Access Compliance Report

Public Rights-of-Way

(Pedestrian Signals)

Intersection ID: N/A	Main Street:	Cross Street: N/A	Location: N/A
ADA ID: BD0800CEACF0	Signal Type: One Push Button-Non APS	Overall Compliance: No	Severity Score: BTN 1: N/A BTN 2: N/A No BTN: N/A
Codes/Mitigation Info/Possible Solution		Field Measurements/Component Compliance

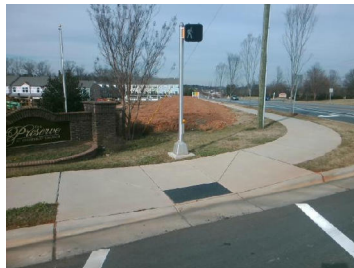
PROW/ADA: TMUTCD 4e.08, R404.2, R404.3

N/A	B 1 FWD Approach Width (in)	N/A	N/A	B 2 FWD Approach Width (in)	N/A
N/A	B 1 FWD Approach Obstruction?	Yes	N/A	B 2 FWD Approach Obstruction?	N/A
N/A	B 1 FWD Approach Obstruction Dist (in)	6.0	N/A	B 2 FWD Approach ObstructionDist (in)	N/A
N/A	B 1 PARA Approach?	Yes	N/A	B 2 PARA Approach?	N/A
N/A	B 1 PARA Approach Constrained?	Yes	N/A	B 2 PARA Approach Constrained?	N/A
Yes	B 1 PARA Approach Reach (in)	10.0	N/A	B 2 PARA Approach Reach (in)	N/A
Yes	B 1 PARA Approach Width (in)	60.0	N/A	B 2 PARA Approach Width (in)	N/A
N/A	B 1 PARA Approach Obstruction?	Yes	N/A	B 2 PARA Approach Obstruction?	N/A
N/A	B 1 PARA Approach Obstruction Dist (in)	8.0	N/A	B 2 PARA Approach ObstructionDist (in)	N/A
No	B 1 Clear Floor Space Slope (%)	6.6	N/A	B 2 Clear Floor Space Slope (%)	N/A
Yes	B 1 Clear Floor Space XSlope (%)	1.8	N/A	B 2 Clear Floor Space XSlope (%)	N/A
N/A	B 1 PAR Slope (%)	N/A	N/A	B 2 PAR Slope (%)	N/A
Yes	B 1 Height (in)	36.5	N/A	B 2 Height (in)	N/A

N/A	B 1 Clear Xing Direction?	Yes	N/A	B 2 Clear Xing Direction?	N/A
	B 1 Crossing Direction	To S		B 2 Crossing Direction	N/A
Yes	B 1 DistanceTo XWalk (in)	0.0	N/A	B 2 DistanceTo XWalk (in)	N/A
No	B 1 DistanceTo Curb (in)	106.0	N/A	B 2 DistanceTo Curb (in)	N/A
Yes	B 1 Diameter (in)	2.0	N/A	B 2 Diameter (in)	N/A

Possible Solutions: Replace Signal Push Button With APS Button on New Post. Remove & Relocate Sign.
